# Groundwater Transfer Review Summary Form

Transfer/PA # T- 13491

Application: T-13491

Applicant Name: Dustin Fox

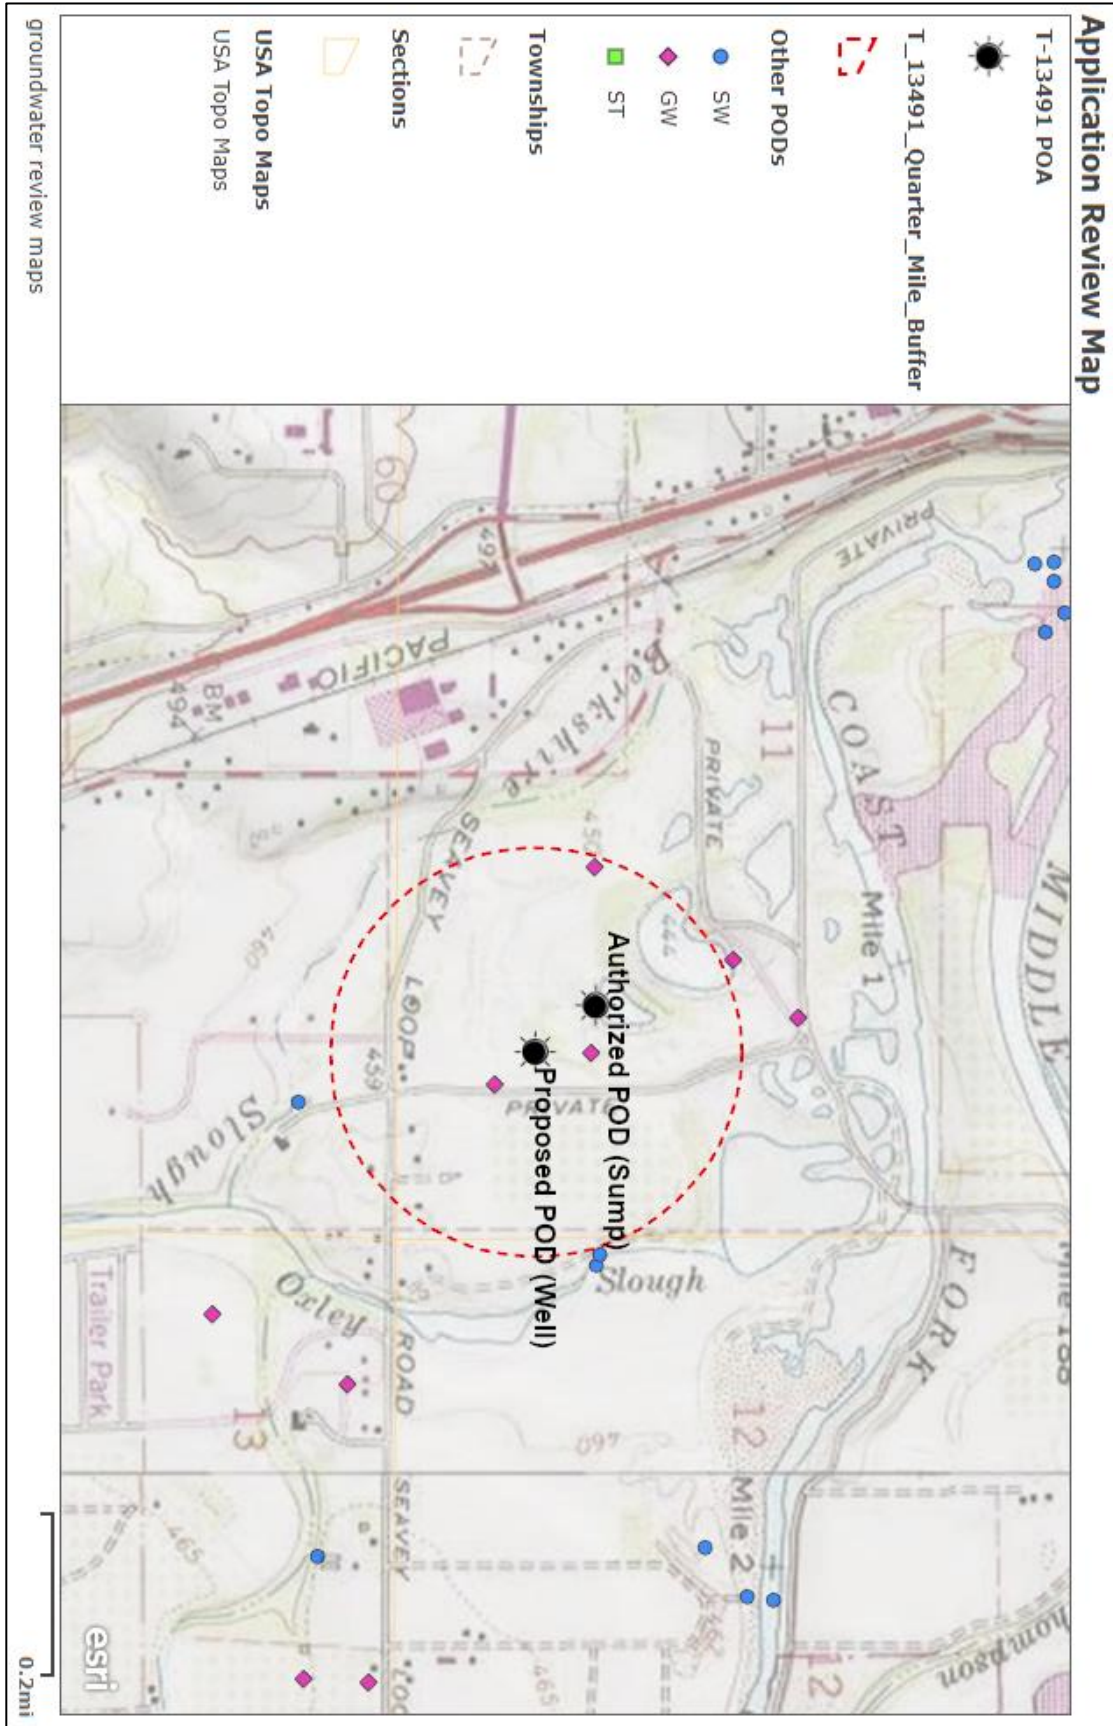
**\*The applicant appears to have checked the wrong boxes in Part 5 of the application: the applicant checked "Point of Diversion" and "Surface Water POD to Ground Water POA" but is simply changing the POA on a Groundwater right so "Point of Appropriation" would be the appropriate box to check.**

- 
1. Basic description of the changes proposed in this transfer: The applicant proposes to change the POA on Cert. 50297 from the authorized POA (a sump) to a new, proposed well. The proposed POA is approx. 450 ft from the original POA. The transfer is for the full acreage on the water right which is 9.75 acres and the full rate of 0.12 cfs.

2. Will the proposed POA develop the same aquifer (source) as the existing authorized POA?  
 Yes     No    Comments: The application does not list construction information for the proposed well (see Table 3 in the Application). The depth of the sump is listed as "unknown" on the original permit but is likely producing from the shallow alluvial aquifer system adjacent to the Coast Fork Willamette. (By definition in OAR 690-200-0050(103) as sump cannot be greater than 10 ft in depth.) Without construction information for the proposed well, a positive finding of same-source cannot be made.

4. a) Will this proposed change, at its maximum allowed rate of use, likely result in an increase in interference with **another groundwater right**?  
 Yes     No    Comments: the new POA is to be a drilled well instead of a large-diameter sump. Drawdown in the aquifer will be much greater from the drilled well than from the sump and this will increase interference with several nearby permitted groundwater rights. There are two permitted groundwater POAs within 400 ft of the proposed new POA.  
 b) If yes, would this proposed change, at its maximum allowed rate of use, likely result in another groundwater right not receiving the water to which it is legally entitled?  
 Yes     No    If yes, explain: Estimated drawdown at the nearest groundwater POAs will likely be less than 3 ft, which is not significant-enough of an impact to cause injury.

5. a) Will this proposed change, at its maximum allowed rate of use, likely result in an increase in interference with **another surface water source**?  
 Yes     No    Comments: Although the proposed change from a sump to a well will increase drawdown in the aquifer near the well, the new POA is farther from nearby surface water sources such that the net effect to surface water will likely be negligible.  
 b) If yes, at its maximum allowed rate of use, what is the expected change in degree of interference with any **surface water sources** resulting from the proposed change?  
 Stream: \_\_\_\_\_     Minimal     Significant  
 Stream: \_\_\_\_\_     Minimal     Significant  
 Provide context for minimal/significant impact: \_\_\_\_\_

7. What conditions or other changes in the application are necessary to address any potential issues identified above: In order ensure the proposed POA is producing from the same source as the original POA, the new well must be constructed to be producing primarily from the alluvial aquifer system and shall be completed within the alluvial material or to no more than 5 ft into competent bedrock underlying the alluvium.

8. Any additional comments: In an alternative to the proposed condition in Item 7, the applicant can submit proposed well construction information and the Department will re-evaluate the application.
